RE: CEAP IR 73 - Natanik Solar Project - Interconnection Feasibility Study Report

Natanik Solar Project

Interconnection Feasibility Study

2024 CEAP IR # 73

Figure A-1: Natanik Solar Project Single Line Diagram for Power Flow Study.

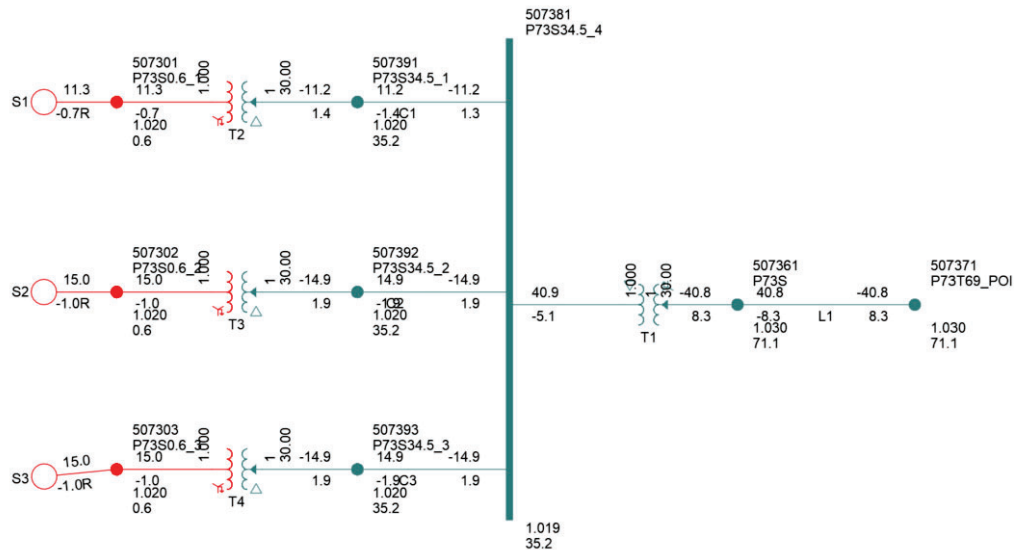
4. According to BC Hydro's TIR, the IC's project must have sufficient reactive power capability over full MW operating range including at the zero MW output level. The Natanik Solar as submitted does not meet the reactive capability requirement at zero MW output level.

The BC Hydro TIR requires IBR power plant to have the dynamic reactive power capability at a minimum of +/- 33% of its MPO at the high voltage side of the IC's switchyard over the full MW operating range.

Based on the PSS/E power flow data submitted by the IC, the proposed generating project would be capable of meeting the BC Hydro's reactive capability requirement at the plant's maximum MW output, which is subjected to further verification in the next stage of interconnection study.

Furthermore, the BCH TIR requires the IC's project to provide sufficient reactive power capability over full MW operating range including at zero MW output level. The proposed wind farm does not meet this requirement at near zero MW output.
